CHANGE ORDER REQUEST PROPOSAL NO. 01

DATE: June 25, 2018
TO: Saunders Construction
PROJECT: **Evanston 3, 6 &**
Evanston WY Stake
721 West Cheyenne Drive, Evanston, Wyoming
PN: 501092517010101

A New Granger 250 for
Evanston 3, 6, &
Evanston WY Stake
721 West Cheyenne Drive
Evanston Wyoming

A G104

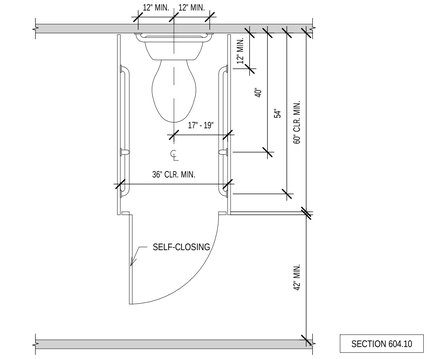
1. The dimension of the grab bar placement on Detail A on sheet G104 has been revised.
2. Multiple sheets have been revised to complete the following:
   Add door 104A at Waiting 104.
   Add door 139A at Waiting 139.
   Add door hardware group 20B to Section 080601 Hardware Group and Keying Schedules.
   Group 20B:

STEEPLE DETAIL

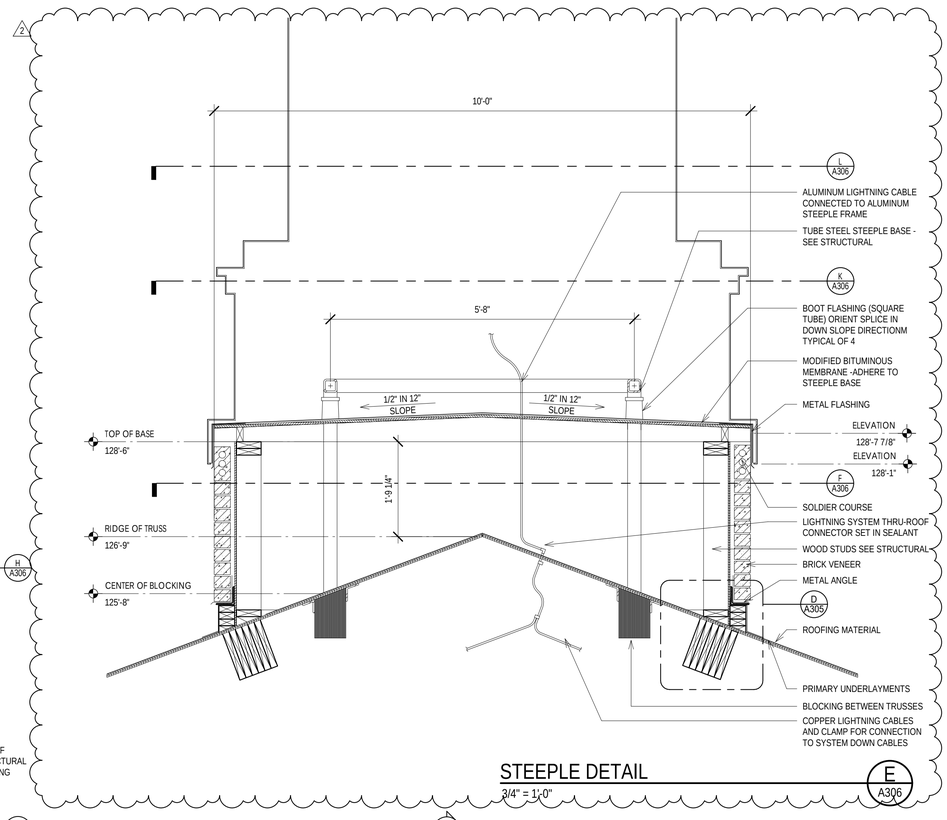
a. 1 set: Smoke Gaskets.
   b. 4 each: Hinges.
   c. 1 each: Latchset Function F75.
   d. 1 each: Stop.
   e. 1 each: Door Grille
3. Revised elevation dimensions on detail E on sheet A306

MAIN FLOOR SIGNAGE LOCATION PLAN

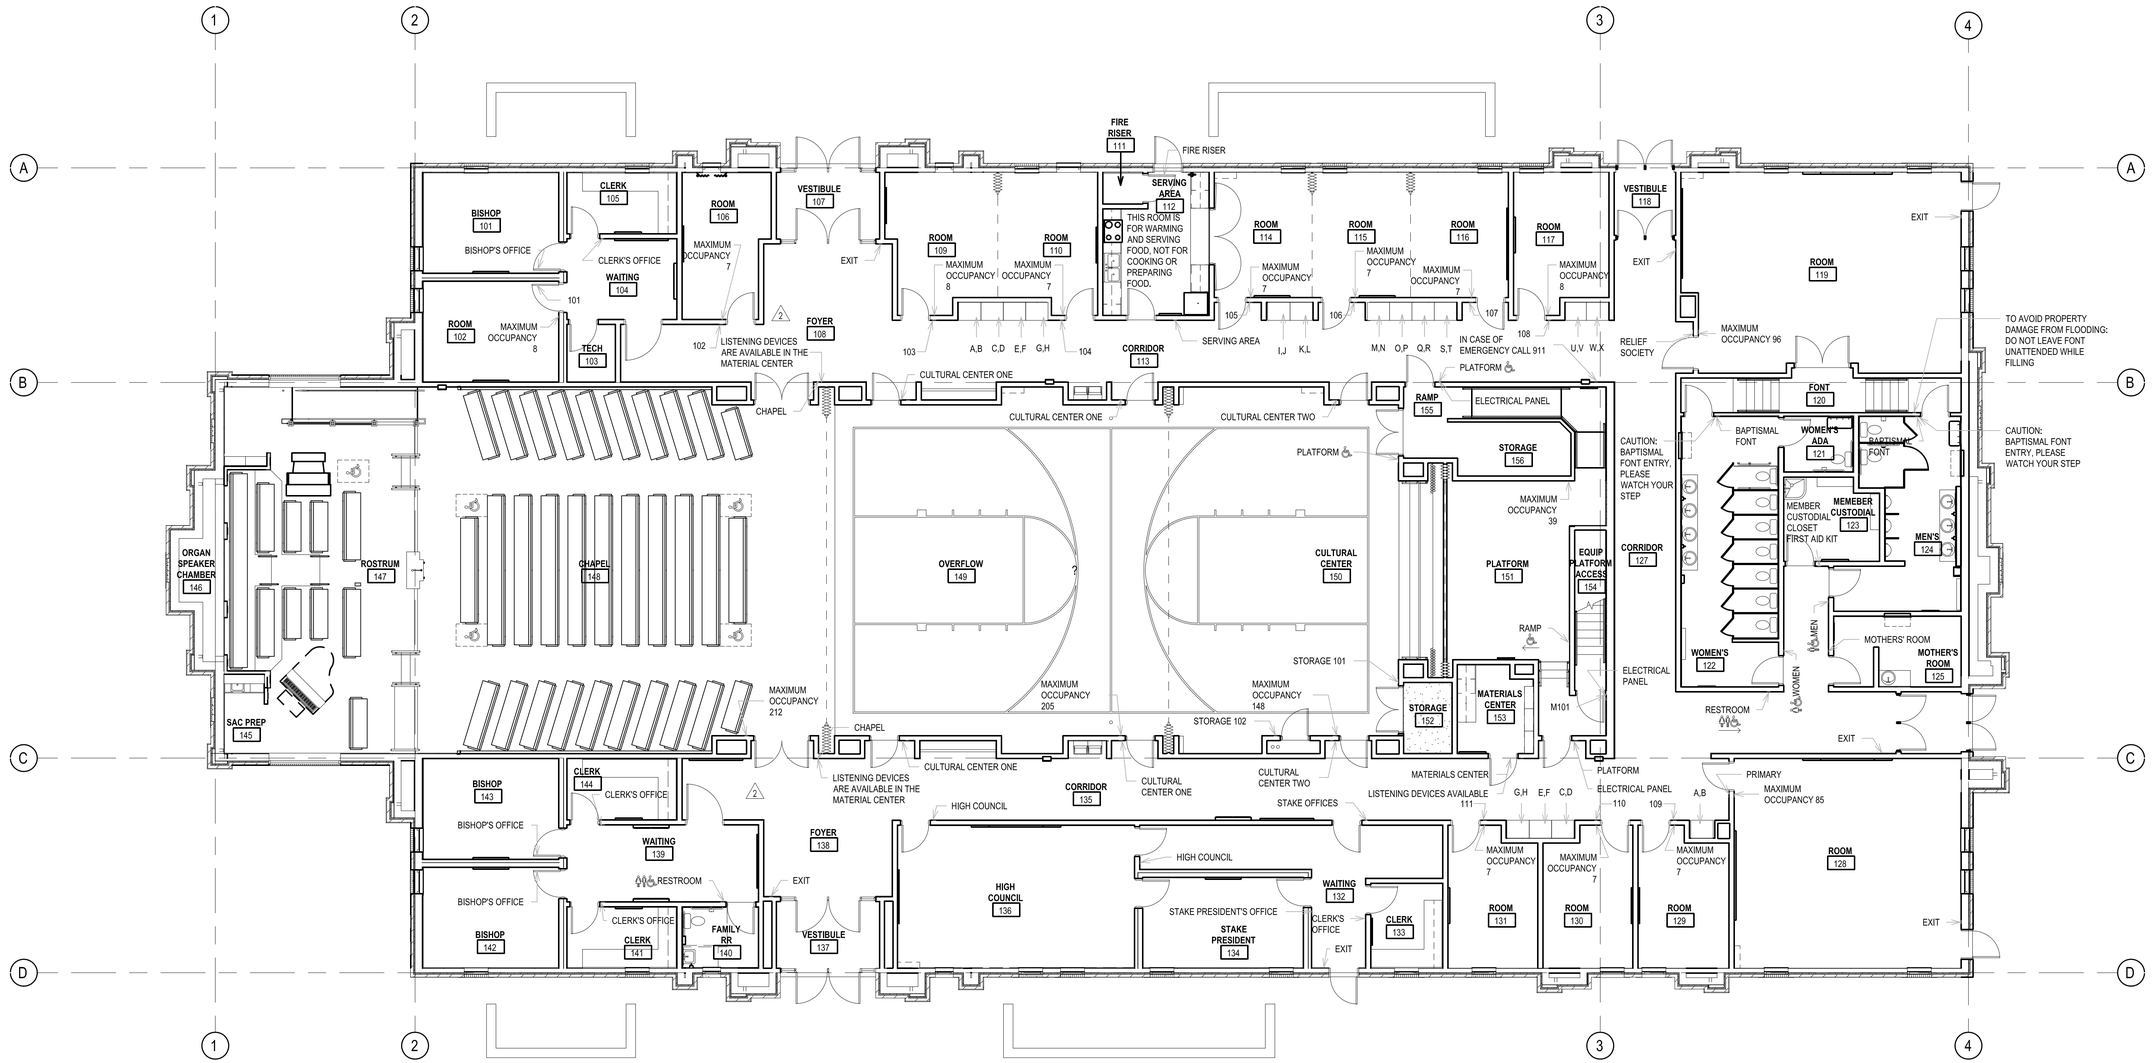
4. Maximum capacity signs are installed at the door to each assembly room. Sheet F102 shows the room signage locations.
5. Wyoming has adopted the 2017 National Electrical Code, refer to the revised sheets E111 and E606.
